**Request for Additional Information No. 194 (598), Revision 0**

**U. S. EPR Standard Design Certification**

**AREVA NP Inc.**

**SRP Section: 04.04 - Thermal and Hydraulic Design**

Figure 04.04-4-1: Incore Instrumentation Location Overview

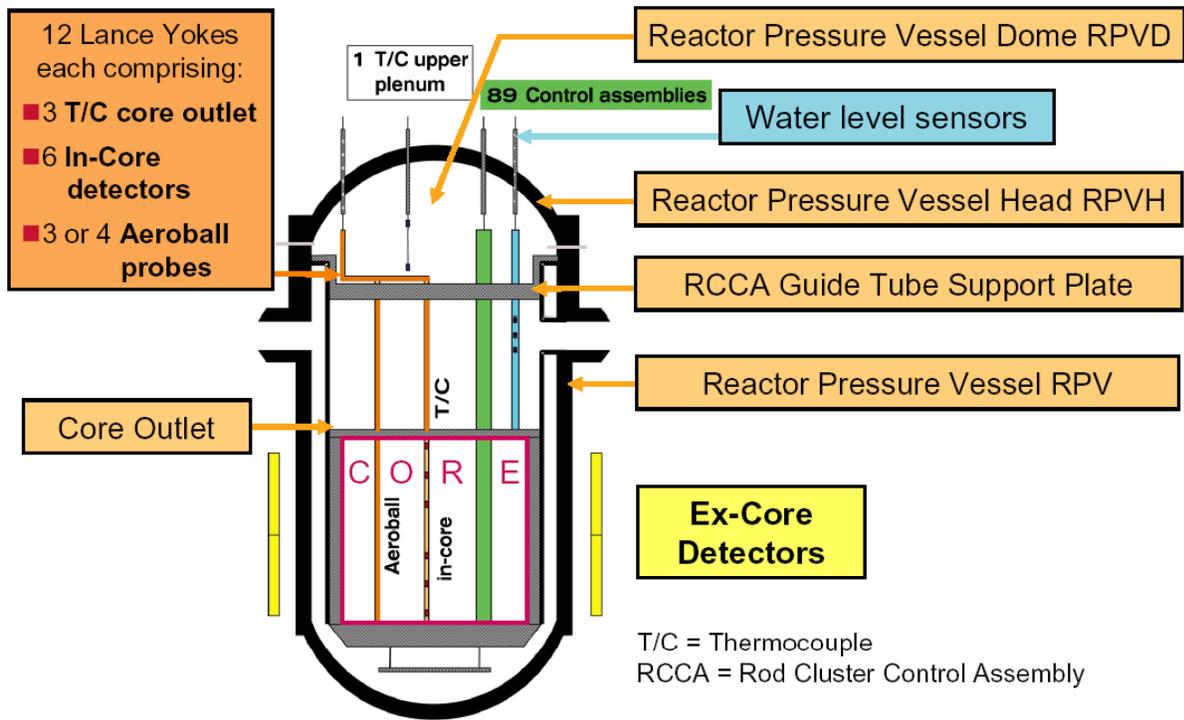
- 1) Please provide P&IDs, related schematics and detail design information of the Aeroball monitoring system (AMS) and power density detector system (PDDS) to supplement and enhance the information contained in the DC FSAR. Provide a more detailed description of the AMS operation including a discussion of a complete calibration cycle with opening and closing times of the system valves. Also please provide information/data in regards to the AMS transport time correction and the effect it may have on the flux measurements. Explain how compensation is performed in POWERTRAX/E program to account for the transport time of the Aeroballs.

Figure 04.04-4-1, Figure 04.04-4-2 and Figure 04.04-4-3 display where the various parts of the incore equipment are located within the RPV.

Figure 04.04-4-13: Aeroball Pneumatic Transport System

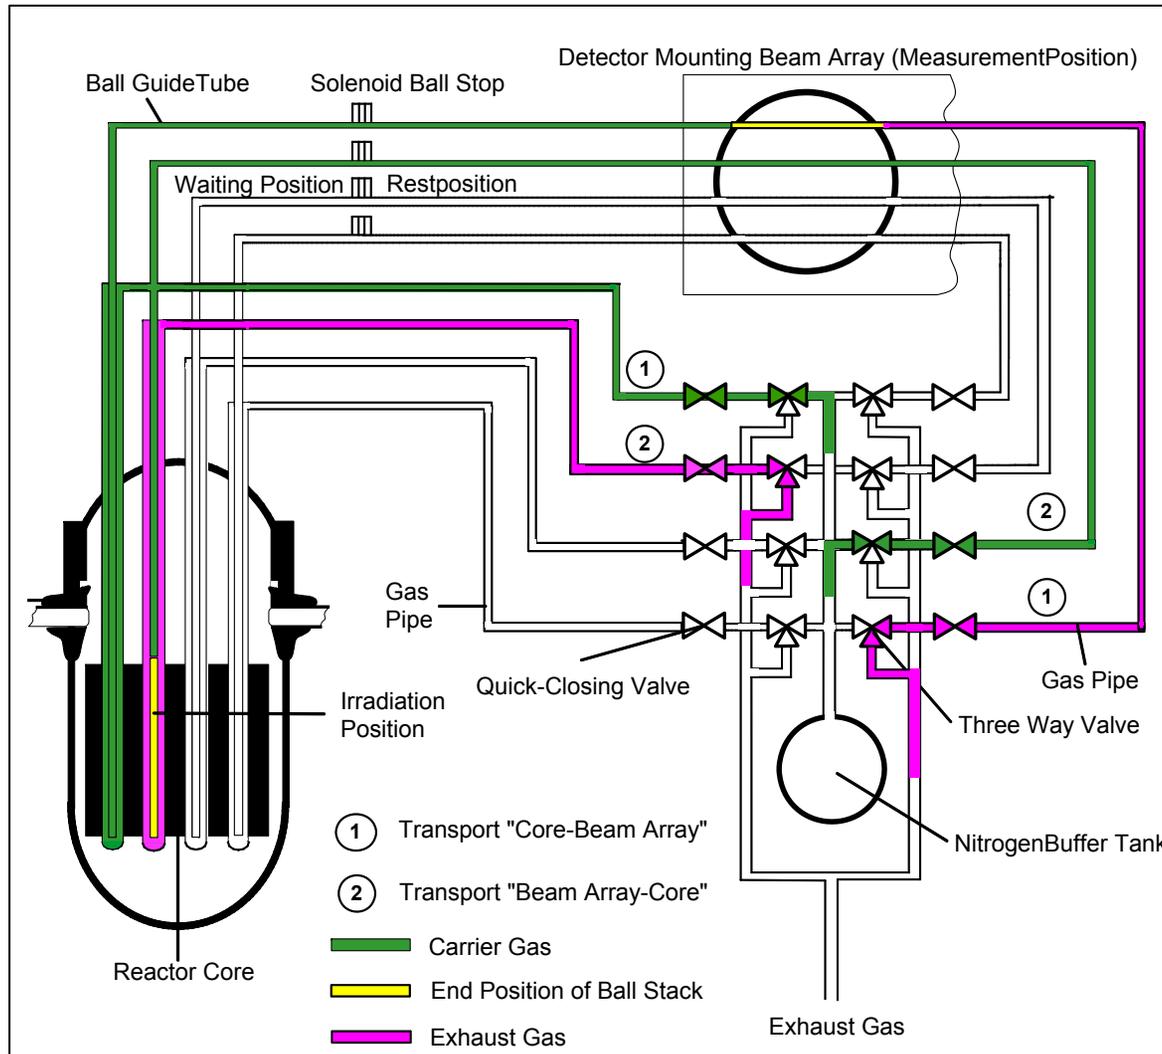
- 2) What are the design criteria for the Aeroball finger tubing? Can the tubing system withstand the RCS nominal system pressure of 2250 psi if the carrying gas supply is cut off? Describe the isolation systems that will actuate in case an AMS tube ruptures inside the vessel.

The AMS has the ability to isolate a leak in an AMS probe by closing two magnetic valves on a pressure and/or humidity signal. Figure 04.04-4-13 shows the location of the magnetic valves for each subsystem. If an event occurs affecting all 40 probes, the magnetic valves close to isolate the entire system.

Figure 04.04-4-15: Aeroball Measurement System Instrumentation Location

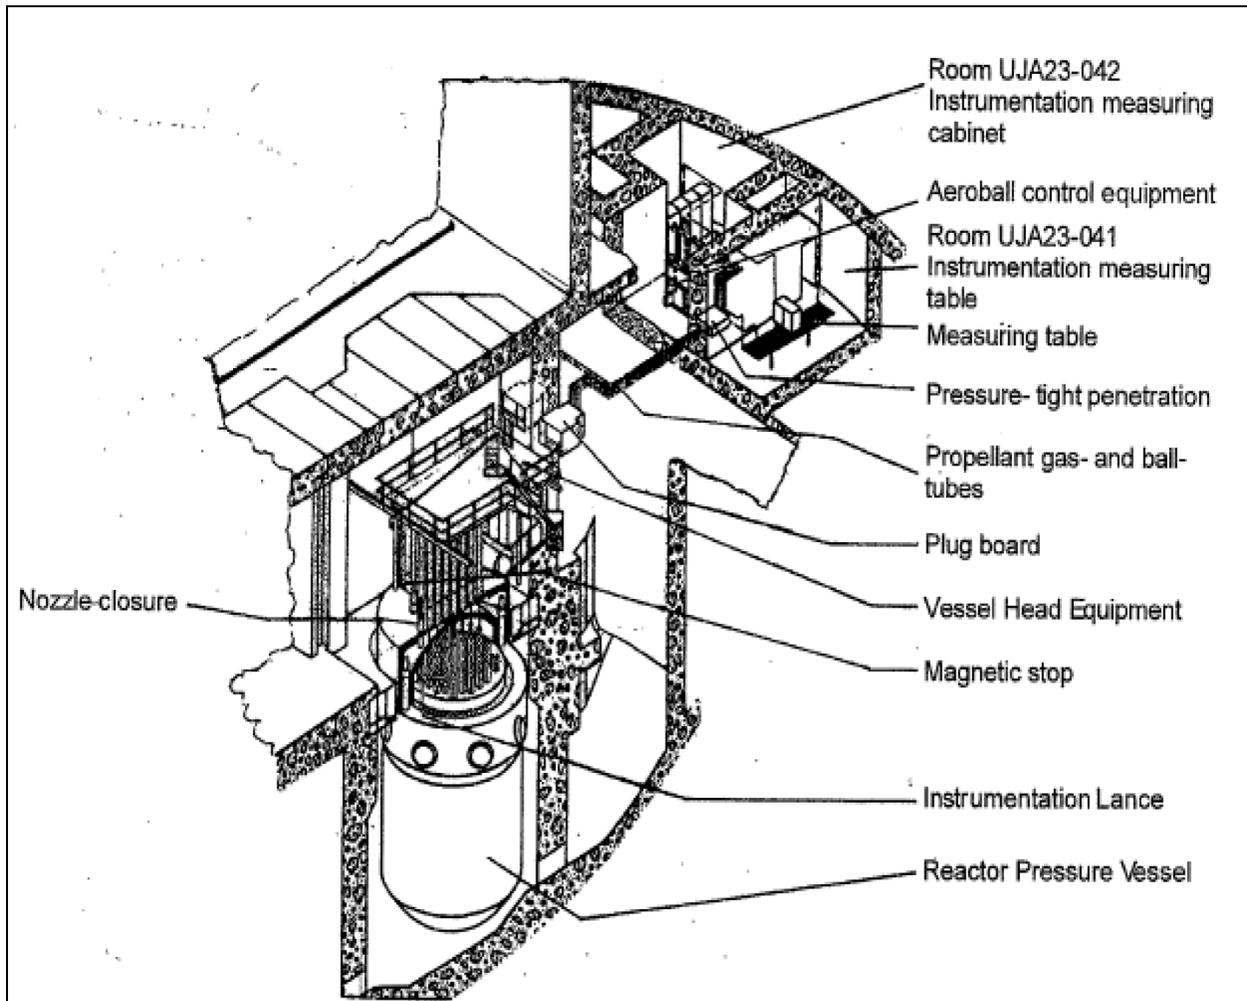
- 4) Where are the Aeroball monitoring system (AMS) counting room and the N2 supply line source located? What are the dose limits in these areas? Can the leakage of a tube cause significant dose in the upper containment?

Pressure and humidity sensors automatically isolate the system by the use of automatically actuated quick-closing valves. The setpoint for the isolation sensors has not yet been determined. Procedures will be established to minimize moisture content in the Aeroball and propulsion-gas tubes. Figures 04.04-4-15 and 04.04-4-16 display where the AMS rooms and system parts are located.

Figure 04.04-4-18: Diagram of a Typical AMS Nitrogen System

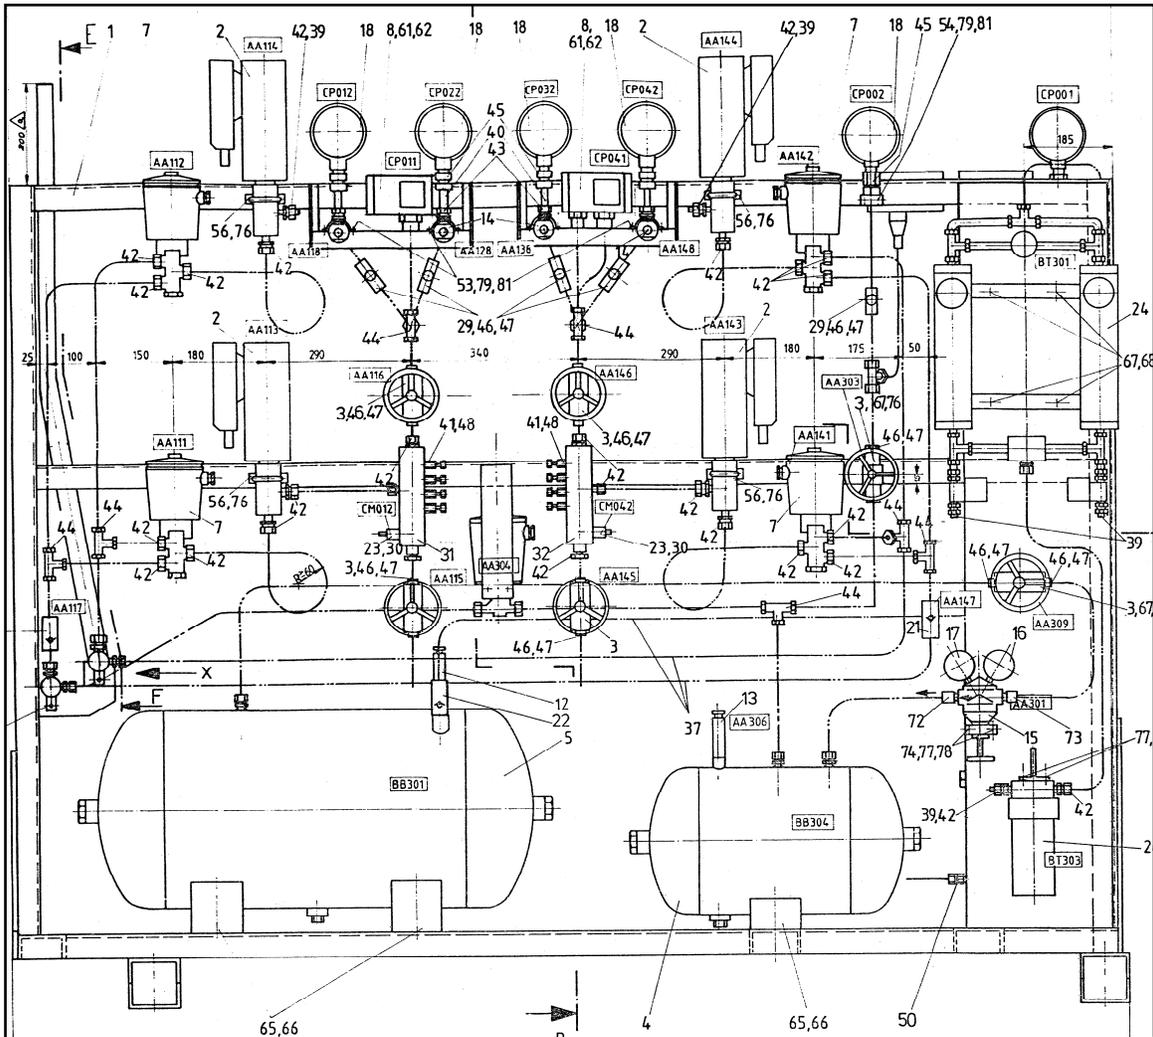
- 5) Please identify the primary nitrogen source for the Aeroball monitoring system (AMS) during normal plant operation. In the event of a nitrogen gas pressure drop in the main supply nitrogen source, describe the process sequence of events to isolate the primary nitrogen source from the AMS. If the primary nitrogen source is isolated, identify the backup nitrogen source to the AMS that ensures continue Aeroball transport operation. In detail, describe the backup source functions and interface with the primary source and AMS. If applicable, show the relevant containment isolation valves on the P&IDs. What is the pressure setpoint at which the solenoid valve isolates the supply line to the main supply system? What is the nominal nitrogen pressure during normal operation? If there is a tube failure within the containment, what is the impact of the leakage on the containment pressure?

Figures 04.04-4-17 and 04.04-4-18 display typical Aeroball Control Equipment (auxiliary component outside RPV, which is not in contact with primary coolant) used to control the nitrogen flow for ball transport into, and out of, the RPV.

**Figure 04.04-4-19: Typical Solenoid Aeroball Stop**

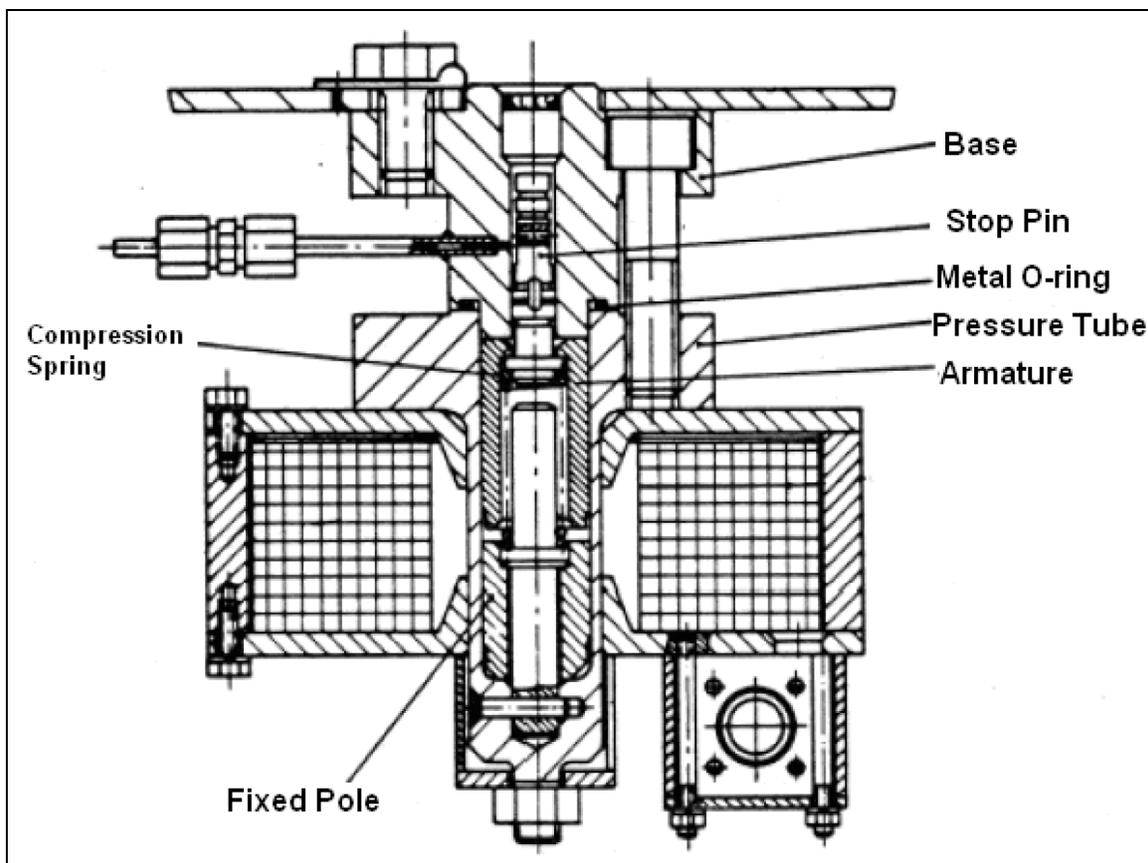
- 6) What is the allowable moisture content in the N2 line? Is the allowable limit controlled by the Technical Specifications? Please provide detail information to clarify how the moisture content is measured and controlled below the limit. There are 40 Aeroball tubes which are grouped into four subsystems representing the symmetrical core quadrants. If the moisture level in any of the subsystems is too high, is there a moisture sensor and controlling mechanism that will shut down and isolate the affected subsystem. If so, describe the operation in detail. Also, provide a detail description of the mechanism which controls the routing of the 10 Aeroballs strings per quadrant onto the counting table. If there is a moisture buildup within a tube, explain in detail how does this affect the following: (1) the flux readings of the Aeroball stack, (2) thermal limits calculations, and (3) the neutronics of the fuel assembly in the vicinity of the tube?

Figure 04.04-4-19 is a typical solenoid Aeroball stop employed in the AMS. The solenoid ball stops, total of 40, are situated in the ball transport tubes between the lance and the measuring

Figure 04.04-4-20: Duration of Aeroball Measurement

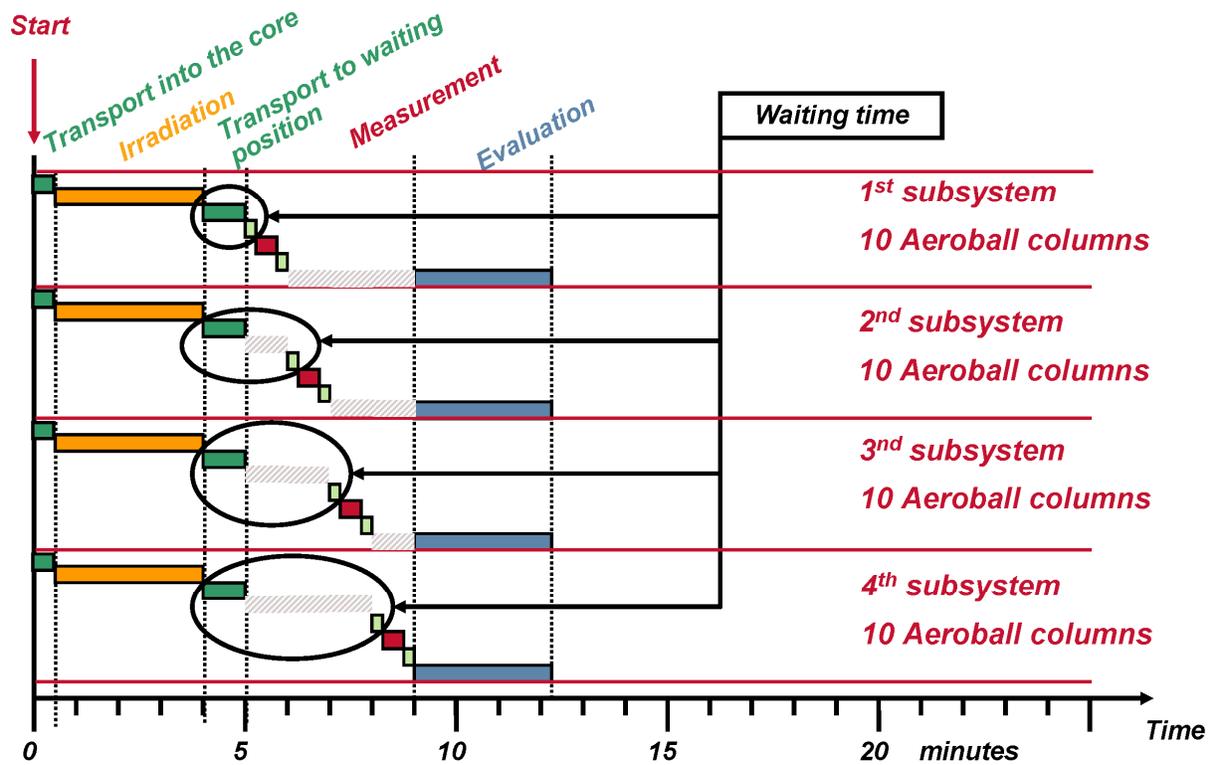
How does the Aeroball monitoring system (AMS) system compensate for the difference in the time of the flux measurements between each quadrant while the ball stacks are in the waiting position?

Figure 04.04-4-20 graphically details the duration period for each step of the Aeroball measurement. The following list provides detail of the event sequence, including the approximate time duration of each event, of an Aeroball measurement:

- Aeroballs are driven into the core using the carrier gas – Approximately 30 seconds.
- Activation of the steel spheres in the core – Approximately three minutes.
- Aeroballs removed from the core – Approximately one minute.
- Measurement of Activation Rates – Approximately three minutes.
- Processing in Aeroball Computer – Approximately four minutes.
- Transfer of Data to Plant Process Computer or POWERTRAXIS system – Approximately 12 minutes after the start of the Aeroball measurement.

Figure 04.04-4-21: Aeroball Measuring Table

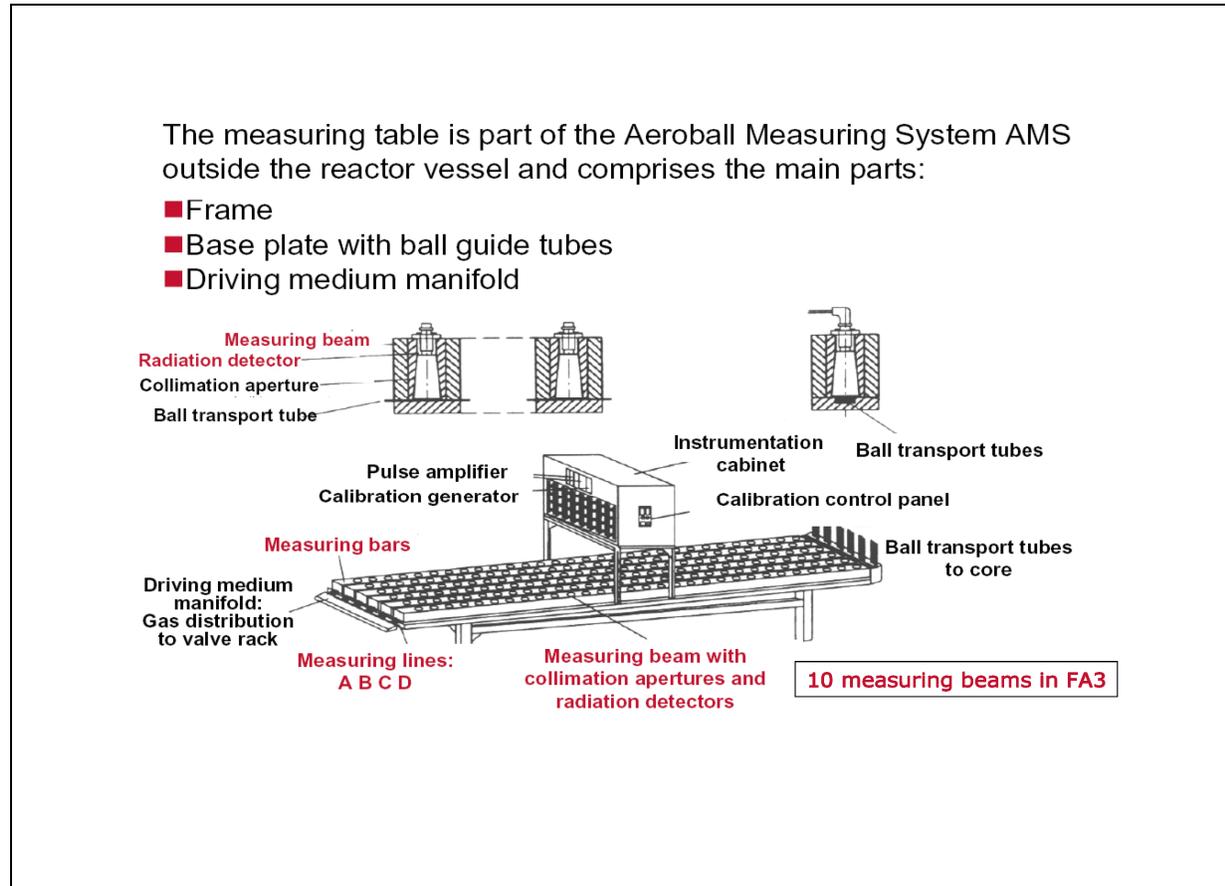
- 15) There are 40 ball stacks with 36 flux measuring detectors per ball stack. Please discuss in detail how the detectors are inter-calibrated to compensate for individual detector signal sensitivity loss? Is this performed in the Aeroball monitoring system (AMS) or POWERTRAX/E?

Passivated implanted planar silicon (PIPS) detectors (see Figures 04.04-4-22 and 04.04-4-23) are situated at regular intervals along the detector beam of the measuring table (see Figure 04.04-4-21). The PIPS have different effective sensitivities due to manufacturing tolerances. These differences in sensitivity are measured and taken into account by the AMS computer by the introduction of a corrective factor that will be specified for each detector during Aeroball measurements and residual activity measurements. During calibration, the calibration source is fixed in a calibration device next to the detector-mounting beam array. The PIPS detector data are loaded one after another into the calibration program. The resulting counting rate is a measure of the sensitivity of the detector channels and is used during calculation of activation values. Results of each calibration are displayed at the operator panel and the measured data is stored in a file that can be printed or displayed on the operator panel at any time.

Figure 04.04-4-25: Measuring Positions of EPR Aeroball Measurement System

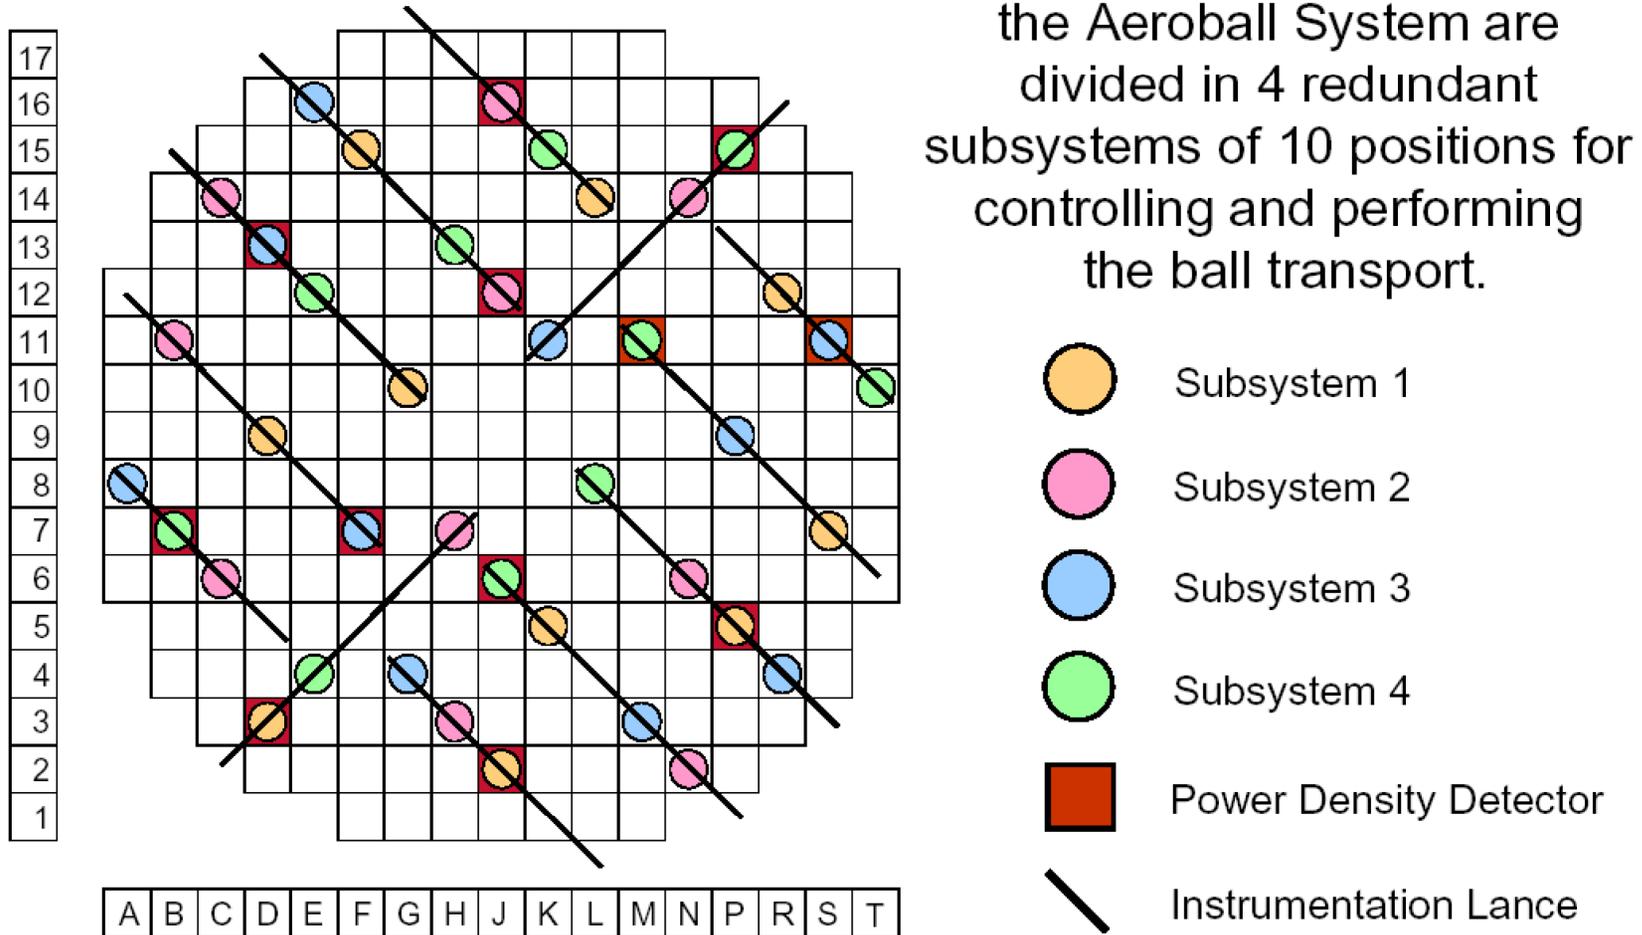
- 16) Please discuss in detail the following questions. How does the Aeroball monitoring system (AMS) compensate for a bad measuring detector? How many bad measuring detectors are permitted per ball stack before the ball stack is declared inoperable? If a ball stack is declared inoperable, how would the flux profile for that location be determined and what effect would there be on the thermal limit calibrations? What is the maximum number of inoperable ball stacks permitted per quadrant and full core? Are these limits regulated by the technical specifications? Is there a limit for the combination of failed in-core detectors and measuring detectors (ball stacks)?

In operating Konvoi plants, as long as all ball stacks of the AMS are in operation at the beginning of the cycle, the AMS provides suitable core flux maps with up to 12 ball stacks inoperable, provided that the 12 inoperable ball stacks are more or less homogeneously distributed over the core. Refer to Figure 04.04-4-25 for U.S. EPR Aeroball measurement positions.
